**RE: 1 Rosemead Rd, Hornsby  
BCA COMPLIANCE ASSESSMENT**

# BCA COMPLIANCE ASSESSMENT

**REGARDING**  
**1 Rosemead Rd, Hornsby**

The project proposal is for alterations and additions and change of use within an existing building to provide for Preschool and Primary School aged services. The existing building is a 2-storey masonry structure with timber floors and a slate roof. The buildings previous use is as a residential dwelling and it is understood that the building “Mt Errington House” holds some heritage significance.

**Figure 1 – Reduced access features to doors.**

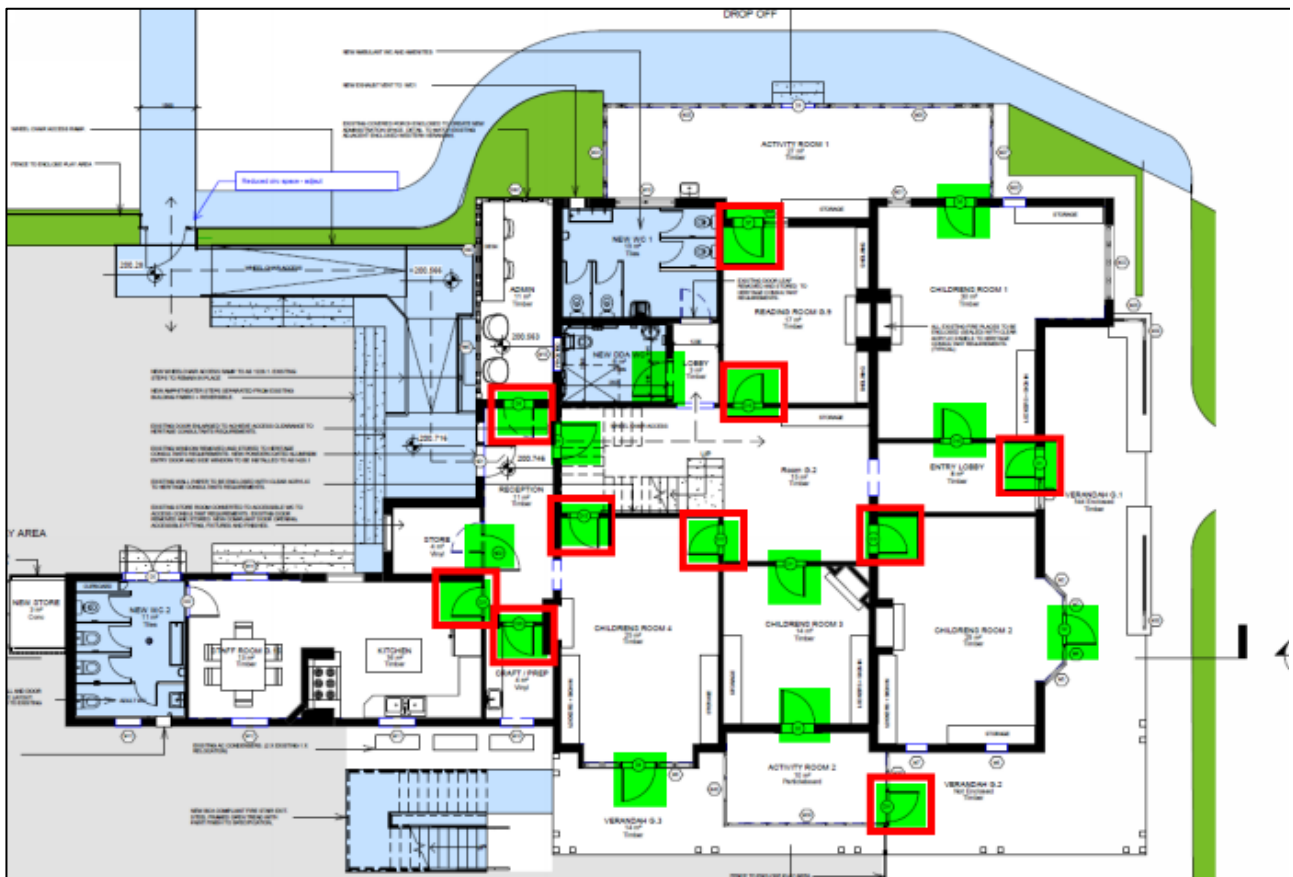
Doors with reduced circulation space shown in **RED**.

Doors with clear door opening width between 800-850mm shown in **GREEN**.

All doors identified above are provided with existing non-accessible door hardware with the exception of the door to the accessible unisex sanitary facility.

**Figure 3** – Nil continuous accessible path of travel from allotment boundary (easternmost entrance)

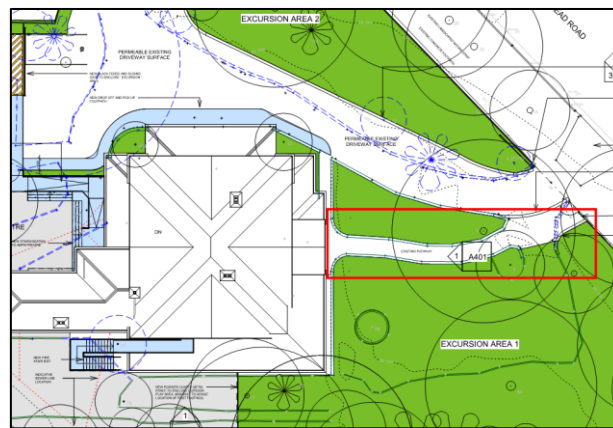
The *reasonableness* of requiring a second accessible path of travel to be provided from the boundary when a direct and convenient path to the building is provided, is questionable.

BCA Specification D3.6 and AS1428.1-2009. See **Figure 8** below (example only – to be designed to comply with BCA Specification D3.6 and AS1428.1-2009 Clause 8

**Figure 4** – Nil accessible sanitary facilities to Level 1

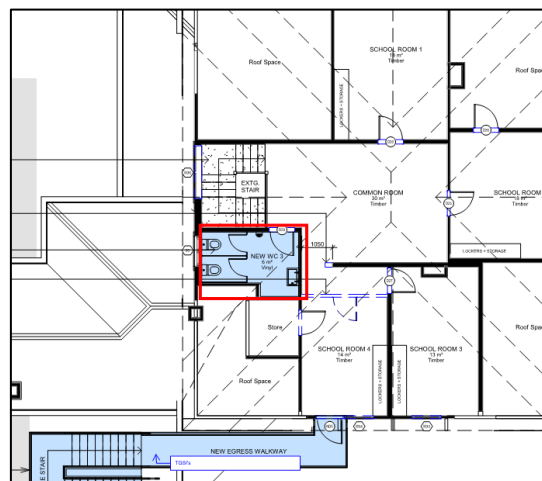
| Sol. No.   | Performance Solution   | DTS Clause  | Performance Requirement<br>Determined in accordance with BCA Clause A0.7 | Methodology   |
|------------|--|-------------|--|---|
|            | <p>This causes a DTS compliance departure with Clause F2.4.</p> <p>See Figure 4 for compliance departure illustration.</p> <p>A qualitative discussion using comparative assessment and other verification methods will be used to demonstrate compliance with the relevant Performance Requirement of the BCA; being DP1 and FP2.1.</p>   |             |  |   |

- a) Way-finding signage shall be provided in a prominent position at the Level 1 banks of toilets to indicate that accessible sanitary facility is available on Ground level. Signage is to comply with BCA Specification D3.6 and AS1428.1-2009. See **Figure 9** below (example only – to be designed to comply with BCA Specification D3.6 and AS1428.1-2009 Clause 8):

**Figure 5** – Reduced pan circulation space to accessible unisex sanitary facility

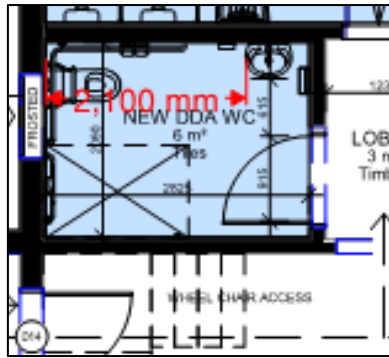
| Relevant DTS Provision                      | <p>BCA Clause F2.4 requires the circulation spaces, fixtures and fittings of all accessible sanitary facilities provided in accordance with Table F2.4(a) and Table F2.4(b) to comply with the requirements of AS 1428.1.</p> <p>AS 1428.1-2009 Clause 15 requires a toilet pan within an accessible sanitary facility to be provided with a 1900mm x 2300mm circulation space.</p> <p>AS 1428.1-2009 Figure 43 permits a 100mm encroachment into the pan circulation space depth via a basin.</p> |

AS 1428.1-2009 Figure 43 permits a 100mm encroachment into the pan circulation space depth via a basin.

**Figure 6** – Reduced clearance at base of central stairs – nil space for handrail extension

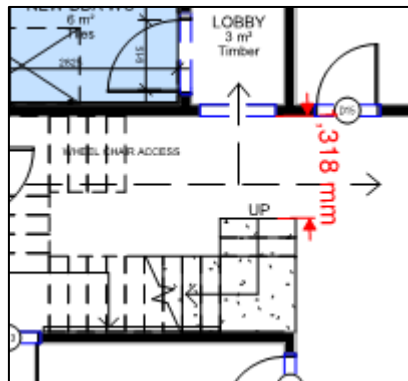
| Sol. No. | Performance Solution   | DTS Clause | Performance Requirement<br>Determined in accordance with BCA Clause A0.7 | Methodology |
|----------|--|------------|--|-------------|
|          | <p>This causes a DTS compliance departure with Clause D3.3.</p> <p>See Figure 6 for compliance departure illustration.</p> <p>A qualitative discussion using comparative assessment and other verification methods will be used to demonstrate compliance with the relevant Performance Requirement of the BCA; being DP1 &amp; DP2.</p> |            |  |             |

Demonstration shall be provided that the handrail to the subject stairs is suitable to assist and provide stability to users, in relation to the nature, volume and frequency of likely usage.

ICC/ANSI A117.1-2009, Clause 505.10.3 (Bottom extension at stairs), refers to the need for a handrail extension at the base of the stairs which is equal to the stair tread depth, but no need exists for a 300mm horizontal handrail projection. Refer to **Figure 11** below for illustration of necessary handrail detailing in this instance.

The raised dome button is noted to have the effect of alerting a person with a vision impairment to the end of a handrail and the subsequent change in surfaces between the stair and the top and bottom landing, and as such is considered to have the equivalent effect to a horizontal handrail extension.

**Figure 1 – Reduced access features to doors.**

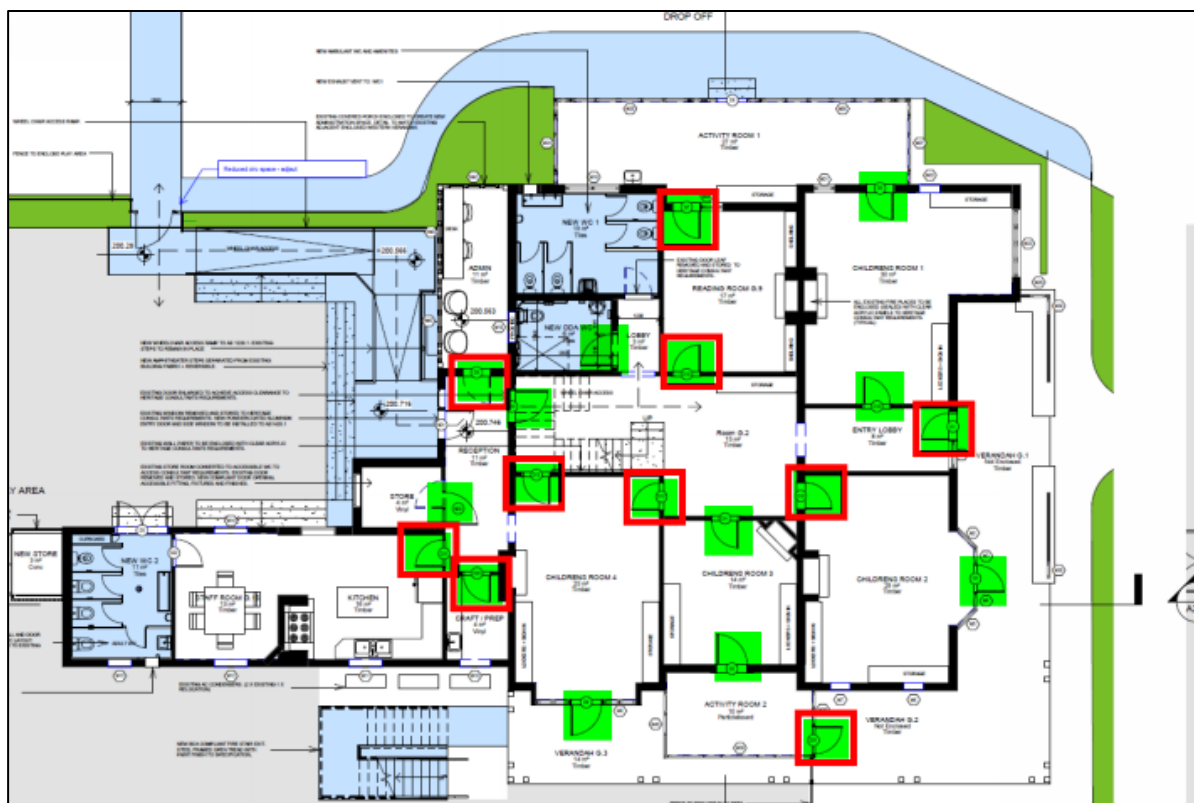
This causes a DtS compliance departure with D3.1.

Doors with reduced circulation space shown in **RED**.

- xiv. Based on this data, it is considered that a clear door width as low as 800mm will provide sufficient clearance to allow 95<sup>th</sup> percentile wheelchair users to pass through the doorway, albeit by potentially requiring a slightly more complex movement pattern and momentarily tucking extremities inboard the wheelchair.
